Fast-track Approvals Act 2024 – Delmore Substantive Application Technical Addendum
FTAA-2502-1015 / BUN60444768

1.0 Technical Specialist – Auckland Transport

From: Tessa Craig, Development Planning Team Lead North/West, Auckland Transport

Date: 18th July 2025

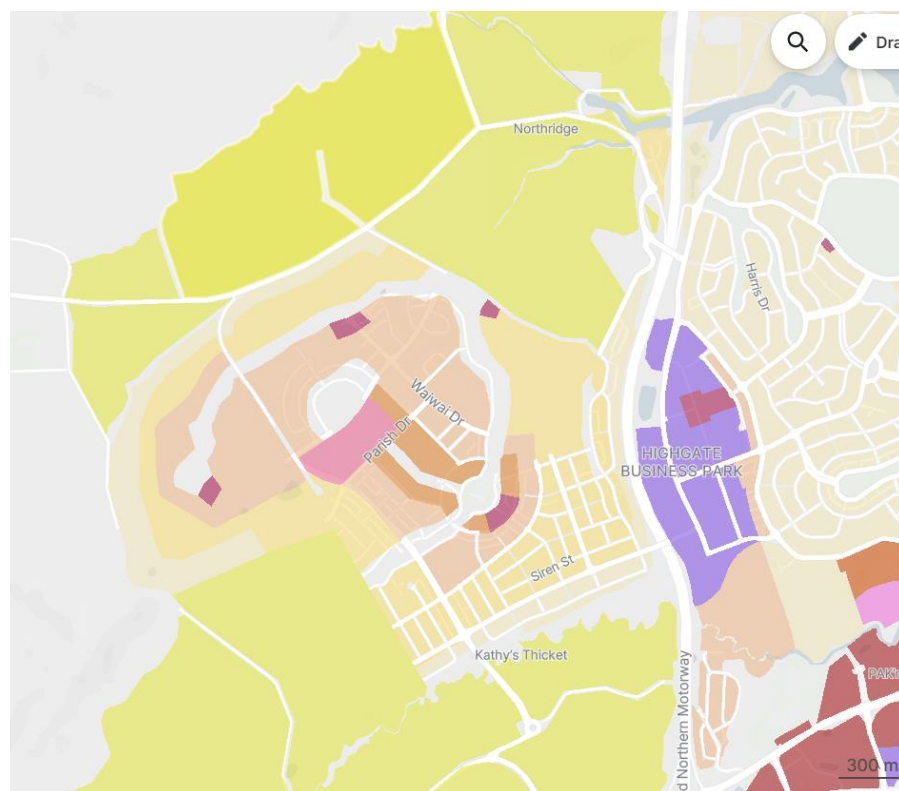
8. In relation to the adverse impact at the SH1 network Section 26-32 of the PTM Consultants Addendum Memo (Appendix 2) (dated 18 July 2025) outlines the remaining concerns at points 26 -32 and this is also supported by the comments in the Beca memo under the heading SH1 Interchange Eastern Roundabout.

2.2 ITEM 1.1.2 – ACCESS TO NOR ROAD

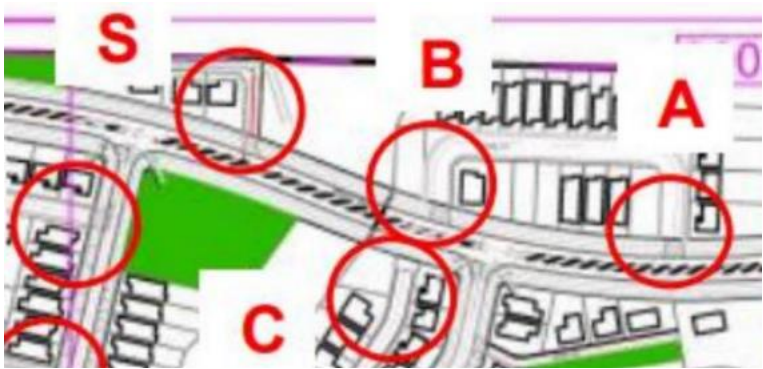
The applicant has revised the number of vehicle crossings in this area, removing vehicle crossing C shown on the previous site plan (copied below). Vehicle crossings S, B and A remain.

The reduction in vehicle crossings is an improvement to the previous concept plan. We note vehicle crossing B creates a risk of overlapping right turns for the inbound movement with the side road intersection to the south. This is a safety risk and we expect it can be addressed through the safety audit and design development process.

Figure 1: Excerpt from Section 5.3 covering maximum longitudinal gradients.

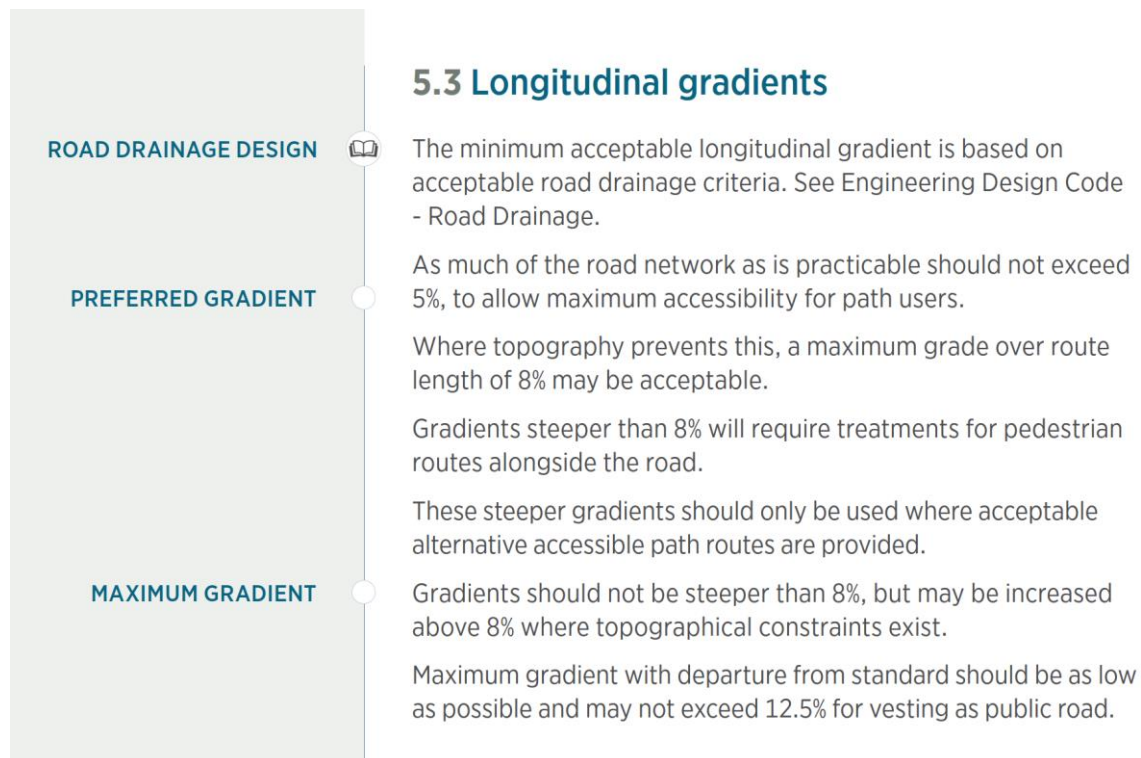
25. There is no such limitation. An excerpt from Section 5.3 is shown in Figure 1 below. While it does state that gradients should not be steeper than 8%, it specifically states that gradients may be over this where topographical constraints exist. The maximum gradient is 12.5% for

26. One of the main reasons steep road gradients are to be avoided is because they deter the use of active modes (walking and cycling) and increase private vehicle usage. The collector roads requested by Auckland Transport in the Delmore development are intended to allow bus routes to come as close as practical to as many dwellings as practical and by doing so help provide a viable alternative to private vehicle usage.

Figure 3: Excerpt from Commute letter dated 12 June showing the Engineering Design Code Cycling Infrastructure. The annotations for Roads 1, 5, and 17 are by Commute.

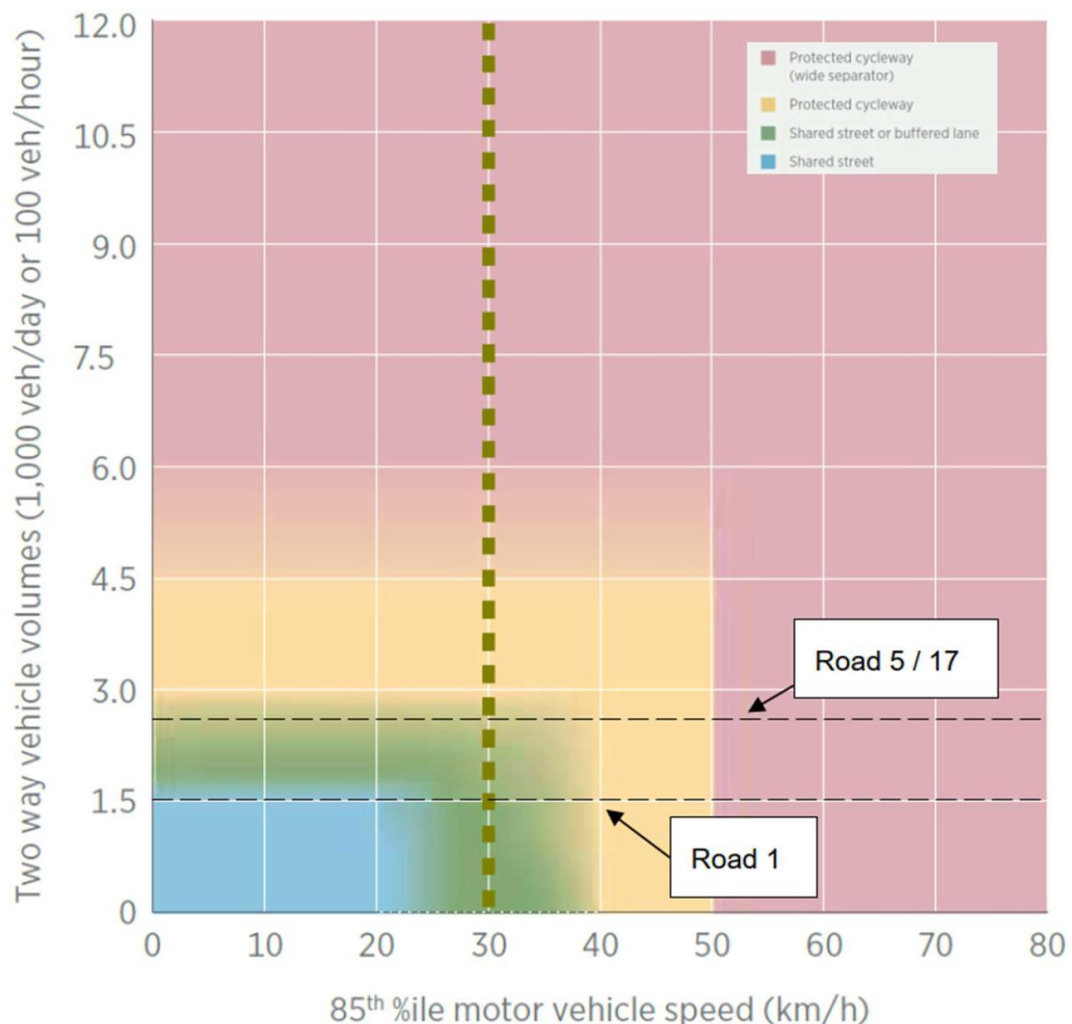
48. The Engineering Design Code Cycling Infrastructure includes a chart which provides additional information on what type of cycling facilities is appropriate based on the criteria. The 12 June letter from Commute assessed Roads 1, 5, and 17 using this chart. The excerpt shown in Figure 3 is from the 12 June letter from Commute showing their assessment for each of the three roads.

49. The annotations added to the chart by Commute indicate that protected cycleways are needed on Road 1, 5, and 17. This is inconsistent with their other comments at section 1.6.6 and 3.4.

Figure 1: NoR6 alignment – single perpendicular stream crossing across the stream.

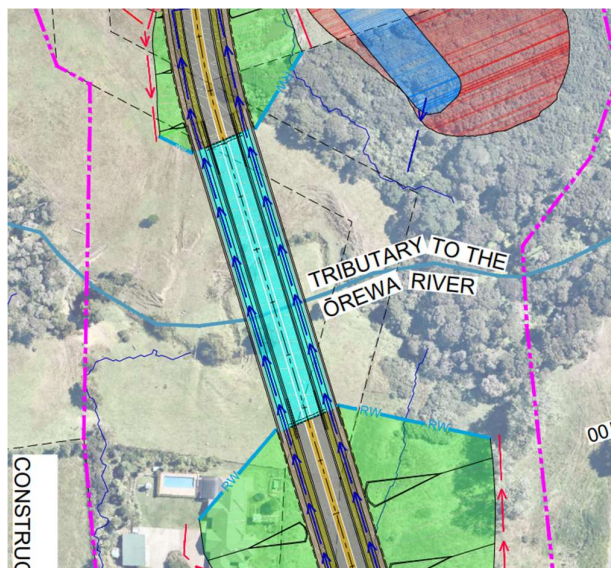
South of the Delmore development where the proposed Vineway alignment connects to Upper Orewa Road, a bridge will need to be provided to cross the streams. The NoR6 alignment has been developed to enable a single stream crossing that is generally perpendicular to the stream (Figure 1 below).

The concept design that was lodged for the NoR hearing showed the approximate position of the bridge, although the potential pier locations have not been identified (Figure 1 above). By comparison, the alignment prepared by McKenzie & Co (26th May 2025) has identified a span configuration and abutment heights to use as a cost comparison, which is more detailed than the design undertaken for the SGA alignment.

Figure 2: Vineway alignment – double stream crossing.

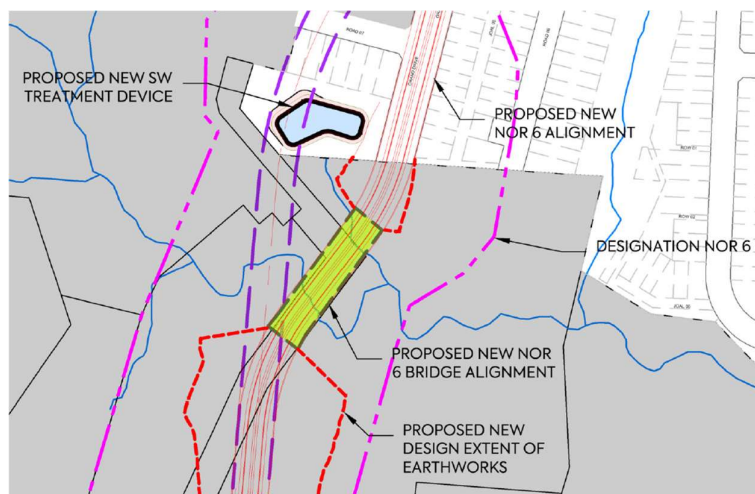
By comparison, the Vineway alignment crosses two streams near a convergence point (Figure 2 below). This is likely to increase environmental risk and reduce opportunities to refine the design further. It will also reduce the construction area available on the eastern side of the structure due as the stream diverts to follow alongside the Vineway structure.
